Access Compliance Report Public Rights-of-Way (Curb Ramps)

Main Street: N/A Cross Street: GILBERT_ST Location: W

ADA ID: RPAT220203100319 Ramp Type: Type 7 - Directional 2 Initial Pass/Fail: Fail Overall Compliance: No Severity Score: 30

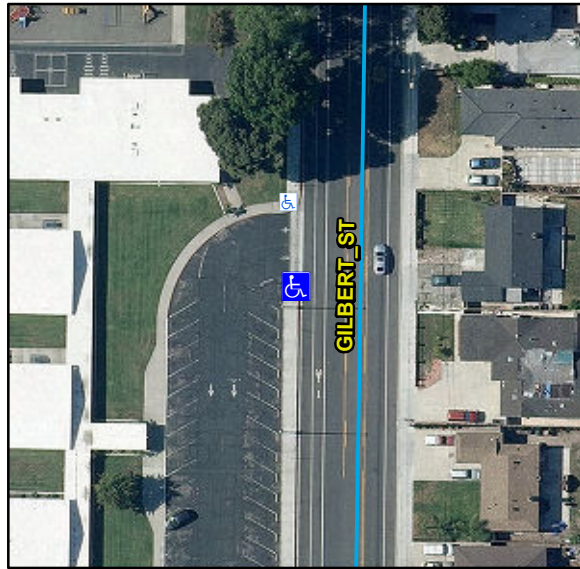
Remove & Replace Entire Ramp. Grind Gutter Lip.

R304.5.1, R304.2.2, R304.3.2, R304.5.3, R302.7.2, STD 1115

Compliance	Description	Data	Compliance	Description	Data
N/A	Ramp Length (in)	89	N/A	Flare Type LT	
Yes	Ramp Width (in)	48			N/A
No	Ramp Run Slope (%)	10.7	N/A	Flare Slope LT (%)	N/A
Yes	Ramp Cross Slope (%)	4.2	N/A	Flare Traversable LT	N/A
N/A	Grade Break	N/A	N/A	Flare Type RT	
N/A	Grade Break Slope (%)	N/A			N/A
N/A	Grade Break Cross Slope (%)	N/A	N/A	Flare Slope RT (%)	N/A
	Addl Para Ramp Left?	Yes	N/A	Flare Traversable RT	N/A
	Addl Para Ramp Right?	No	N/A	DWS Provided	N/A
N/A	Landing Present	N/A	N/A	DWS Contrast	N/A
N/A	Landing Length (in)	N/A	N/A	DWS Length (in)	N/A
N/A	Landing Width (in)	N/A	N/A	DWS Full Width	N/A
N/A	Landing Run Slope (%)	N/A		DWS Offset Type	N/A
N/A	Landing Cross Slope (%)	N/A	N/A	DWS Left Offset (in)	N/A
N/A	Landing Movement Obstructed?	N/A	N/A	DWS Right Offset (in)	N/A
	Landing Movement Type	N/A			
N/A	Landing Shared	N/A			
N/A	Marked Crosswalk 1	No	N/A	Clear Space	N/A
	Crossing 1 Direction	N	N/A	Clear Space To Crosswalk (in)	N/A

Marked Crosswalk 1 Width (in)	N/A			
N/A	Ramp Inside Crosswalk 1	N/A			
	Crossing 1 Slope (%)	0			
	Crossing 1 Cross Slope (%)	5.9			
N/A	Gutter Ponding	N/A	N/A	Curb Slope	5.3
No	Gutter Lip Height (in)	1		Road Run Slope (%)	N/A
N/A	Gutter Run Slope (%)	N/A		Road Cross Slope (%)	N/A
N/A	Gutter Cross Slope (%)	N/A		Parallel Ramp Side	Left
Yes	Overall Surface Condition	Acceptable	Yes	Perp Joint Present	Yes
	Cross Gutter Present?	Yes		Spandrel Present?	Yes
	Replace Cross Gutter?	No		Replace Spandrel?	No
